MIL-M-10323A(MU)
AMENDMENT 3
22 November 1971
SUPERSEDING
AMENDMENT 2
15 December 1970

MILITARY SPECIFICATION

MOUNT, TELESCOPE: M48

This amendment forms a part of Military Specification MIL-M-10323A(MU), dated 16 October 1967.

FIGURE 1

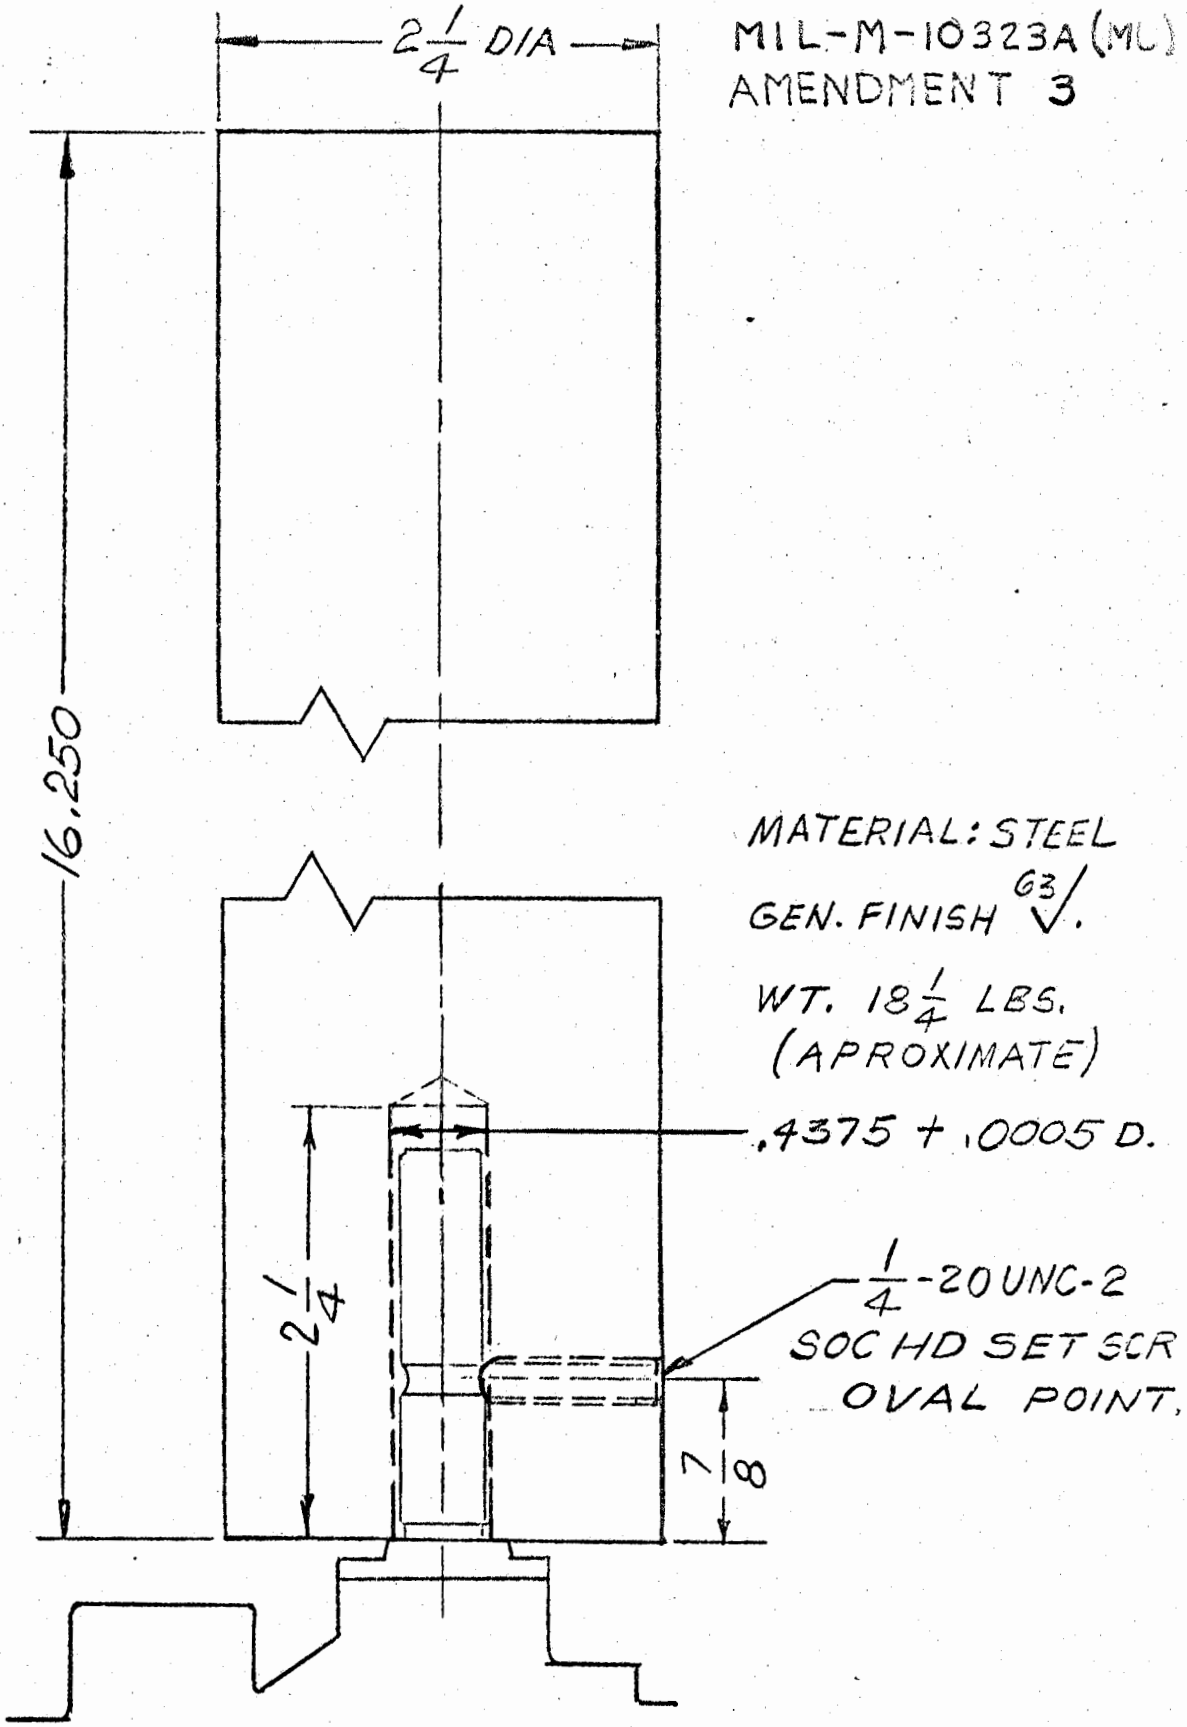
Paragraph 4.6.4 Accuracy: Add the following:

* 4.6.4 Accuracy.- The tests in 4.6.4.1, through 4.6.4.5 shall be performed utilizing a dummy load simulating Periscope, B.C. M65, with the approximate weight, outside dimension and configuration as shown in Figure I. The dummy load shall be mounted vertically on the mounting spindle of Telescope Mount: M48. Secure the dummy load to the spindle by means of its socket head set screw."

* Add Figure 1.
